UNITED STATES PATENT AND TRADEMARK OFFICE

Office Action Summary	Application No. 09/866,092	Applicant(s) MCCORMACK ET AL.	
	Examiner Eugene Lee	Art Unit 2815

DETAILED ACTION

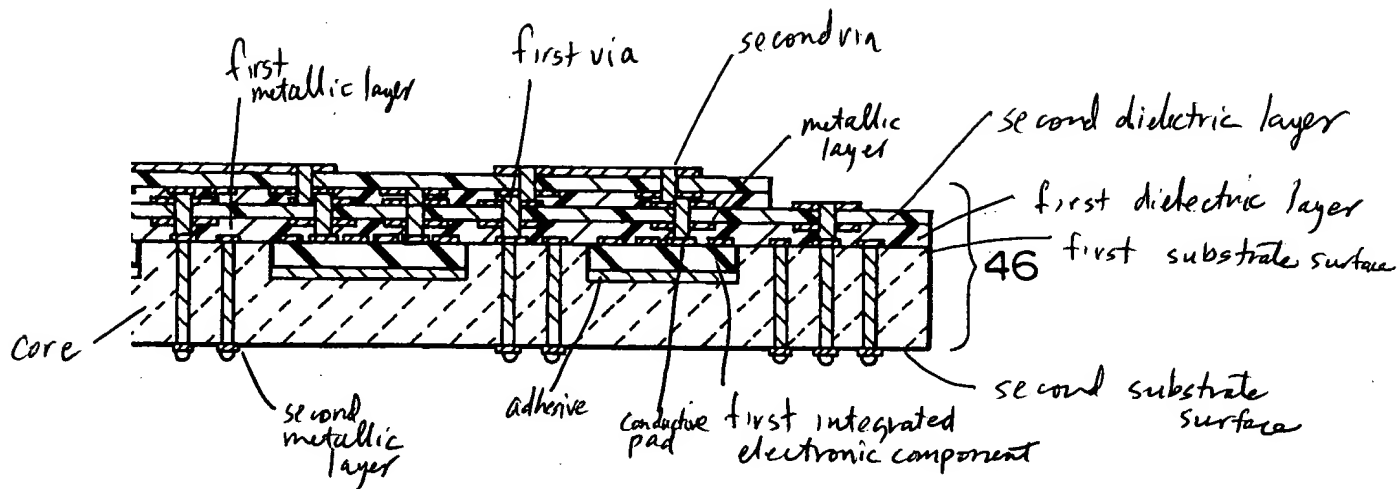
2. Claims 28 and 29 are objected to because of the following informalities: in line 2 of both claims, there is a typographical error in the limitation “additionally comprising wherein said first prefabricated integrated electronic component.” Appropriate correction is required.
